Access Compliance Report Public Rights-of-Way (Curb Ramps)

Main Street: BLUE_SPRUCE_DR Cross Street: MAGNOLIA_DR Location: N

ADA ID: RPAT211101144051 Ramp Type: Type 4 - Parallel Initial Pass/Fail: Fail Overall Compliance: No Severity Score: 32

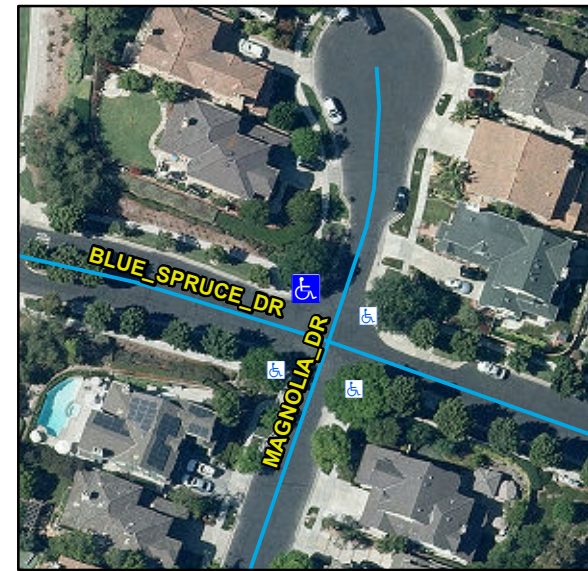
Compliance	Description	Data	Compliance	Description	Data
N/A	Ramp Length LT (in)	110	N/A	Ramp Length RT (in)	115
Yes	Ramp Width LT (in)	53	Yes	Ramp Width RT (in)	53
Yes	Ramp Run Slope LT (%)	1.6	No	Ramp Run Slope RT (%)	14.6
No	Ramp Cross Slope LT (%)	3.3	No	Ramp Cross Slope RT (%)	2.1
N/A	Landing Present	N/A	N/A	DWS Provided	N/A
N/A	Landing Length (in)	N/A	N/A	DWS Contrast	N/A
N/A	Landing Width (in)	N/A	N/A	DWS Length (in)	N/A
N/A	Landing Run Slope (%)	N/A	N/A	DWS Full Width	N/A
N/A	Landing Cross Slope (%)	N/A		DWS Offset Type	N/A
N/A	Landing Movement Obstructed?	N/A	N/A	DWS Offset Left (in)	N/A
	Landing Movement Type	N/A	N/A	DWS Offset Right (in)	N/A
N/A	Landing Shared	N/A			
N/A	Clear Space	Yes			
N/A	Clear Space To Crosswalk (in)	N/A			
N/A	Marked Crosswalk 1	No	N/A	Marked Crosswalk 2	No
	Crossing 1 Direction	SW		Crossing 2 Direction	SE
	Marked Crosswalk 1 Width (in)	N/A		Marked Crosswalk 2 Width (in)	N/A

N/A	Ramp Inside Crosswalk 1	N/A	N/A	Ramp Inside Crosswalk 2	N/A
	Crossing 1 Slope (%)	3.4		Crossing 2 Slope (%)	6
	Crossing 1 Cross Slope (%)	7.9		Crossing 2 Cross Slope (%)	3.6
N/A	Gutter Ponding	N/A	N/A	Curb Slope	9.5
Yes	Gutter Lip Height (in)	0		Road Run Slope (%)	5.4
N/A	Gutter Run Slope (%)	N/A		Road Cross Slope (%)	4.7
N/A	Gutter Cross Slope (%)	N/A	No	Perpendicular Joint Present	No
Yes	Overall Surface Condition	Acceptable			
	Cross Gutter Present?	No		Spandrel Present?	No
	Replace Cross Gutter?	N/A		Replace Spandrel?	N/A

Remove & Replace Curb Ramp With Two New Directional Ramps or Equivalent.
